Model: DF64		Date: 15-Jul-97	No: 1
Modified Article: Parts Catalog Correction		Prepared by: S.Hizen	
From: QAC 1st Field Information Dept.			
Reason for Modification:	<input checked="" type="checkbox"/> Parts catalog correction <input type="checkbox"/> Vendor change <input type="checkbox"/> To meet standards <input type="checkbox"/> To facilitate assembly <input type="checkbox"/> To improve reliability    (    ) <input checked="" type="checkbox"/> Part standardization <input type="checkbox"/> Other

Model: DF64		Date: 15-Sep-97	No: 2
Modified Article: Parts Catalog Correction		Prepared by: J.Kasamoto	
From: QAC 1st Field Information Dept.			
Reason for Modification:	<input checked="" type="checkbox"/> Parts catalog correction <input type="checkbox"/> Vendor change <input type="checkbox"/> To meet standards <input type="checkbox"/> To facilitate assembly <input type="checkbox"/> To improve reliability    (    ) <input type="checkbox"/> Part Standardization <input type="checkbox"/> Other

## Page 9

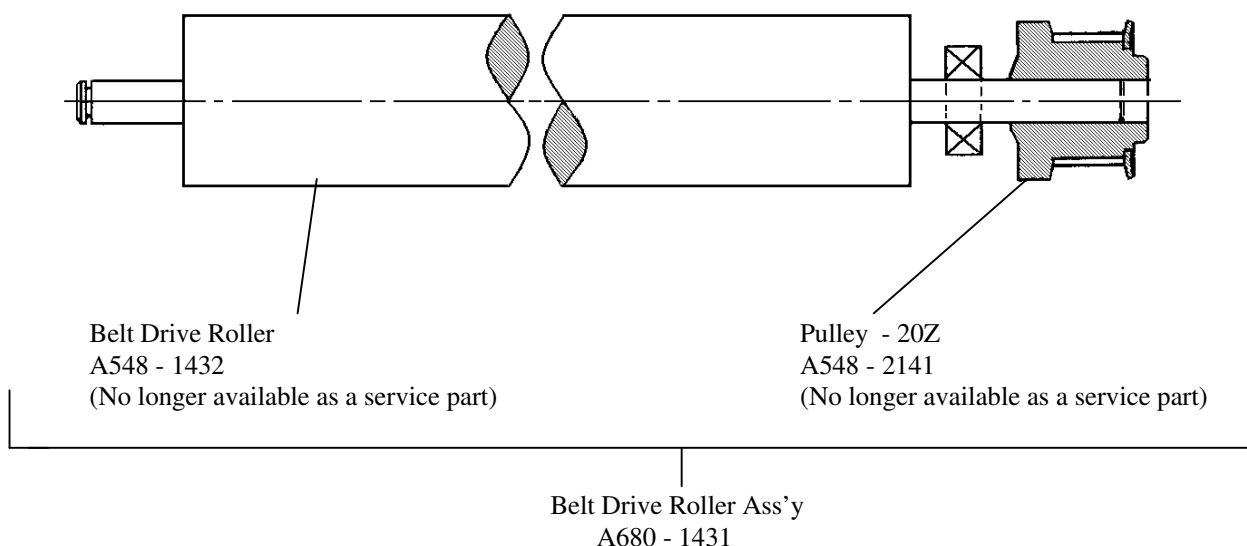
The individual part numbers for the belt drive roller and the 20Z timing pulley are listed in the parts catalog, but the roller shaft is actually press-fit into the pulley on the production line.

The 20Z pulley cannot be installed on the roller shaft in the field. A part number for the belt drive roller assembly has been assigned instead of separate numbers for the belt drive roller and the timing pulley.

Old part number	New part number	Description	Qty	Int	Index	Note
A548-1432		Belt Drive Roller	1		1	
A548-2141		Timing Pulley - 20Z	1		13	
	A680-1431	Belt Drive Roller Ass'y	1	X/O	1

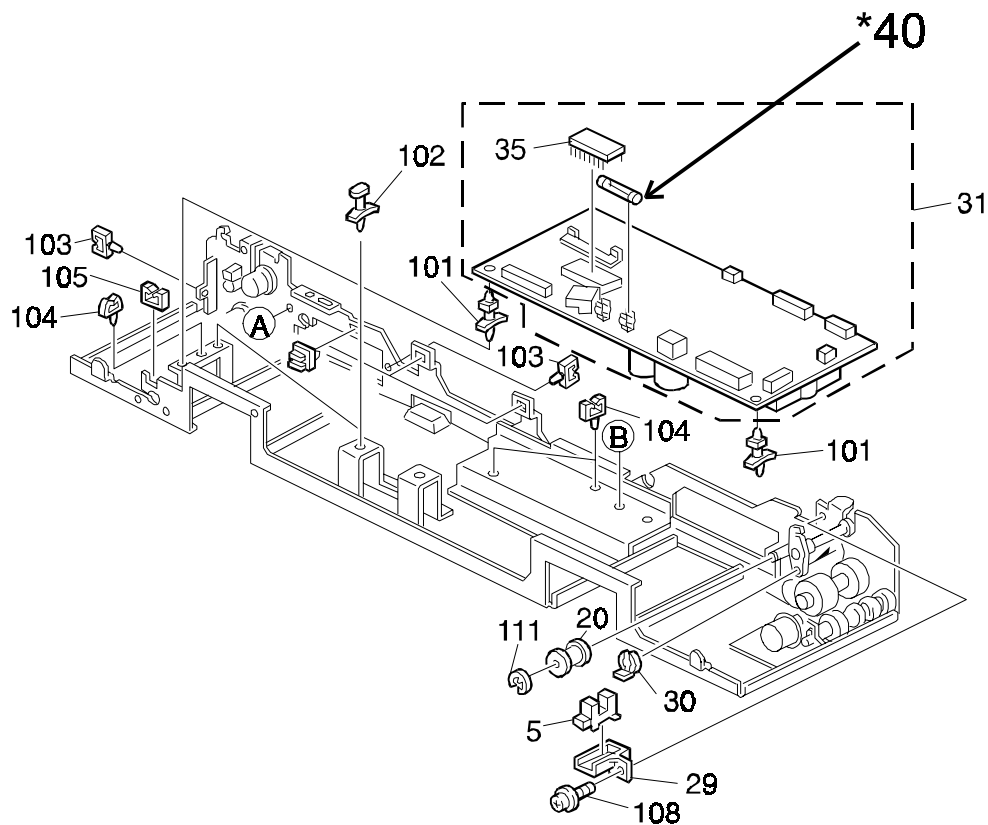
Please add the following part to your parts catalog.

New part number	Description	Qty	Page	Index
1107 0750	Fuse - 3.15A 250V	1	13	40

## Page 13

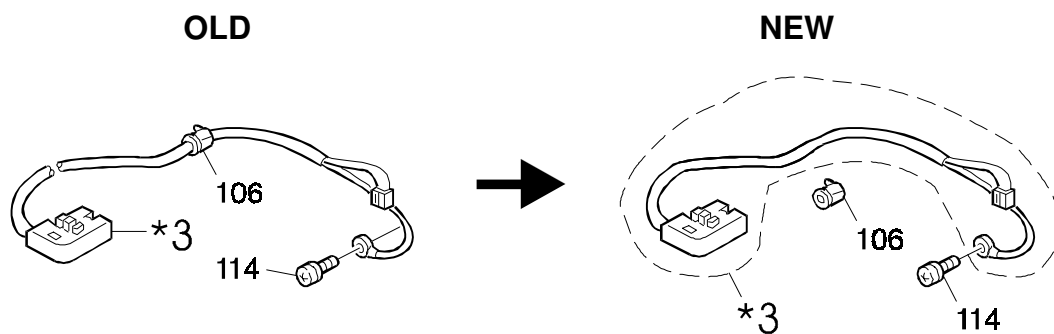
Please correct your parts catalog as follows:

Old part number	New part number	Description	Page	Index
A548 5281	A548 5280	Interface Harness	13	3

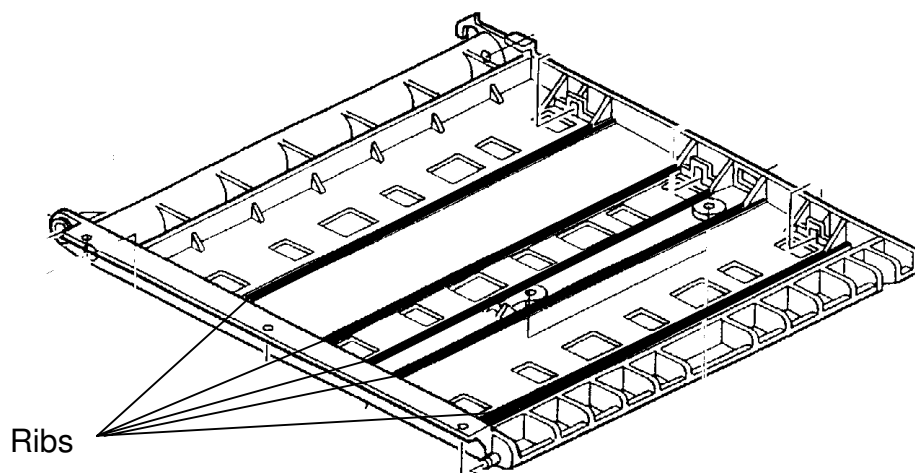
To increase the tolerance against original jams, the material of the transport belt has been changed. The interchangeability code is O/O.

Old part number	New part number	Description	Qty	Int	Page	Index	Note
A5481481	<b>A5481482</b>	Transport Belt	1-1	O/O	9	10

## Page 12, 13

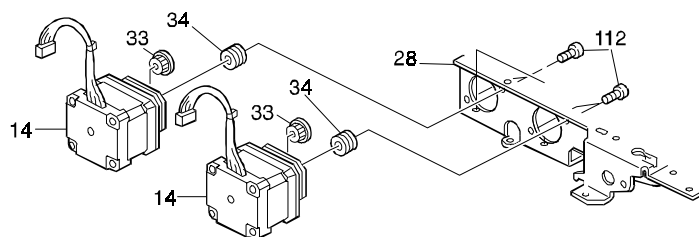
The P/N AX050108 (Stepping Motor: index No.14) does not come with the motor harness. Please add the following part number, and correct the illustration in your parts catalog as follows:

New part number	Description	Qty	Page	Index
A663 5270	Motor Harness	2	13	*40
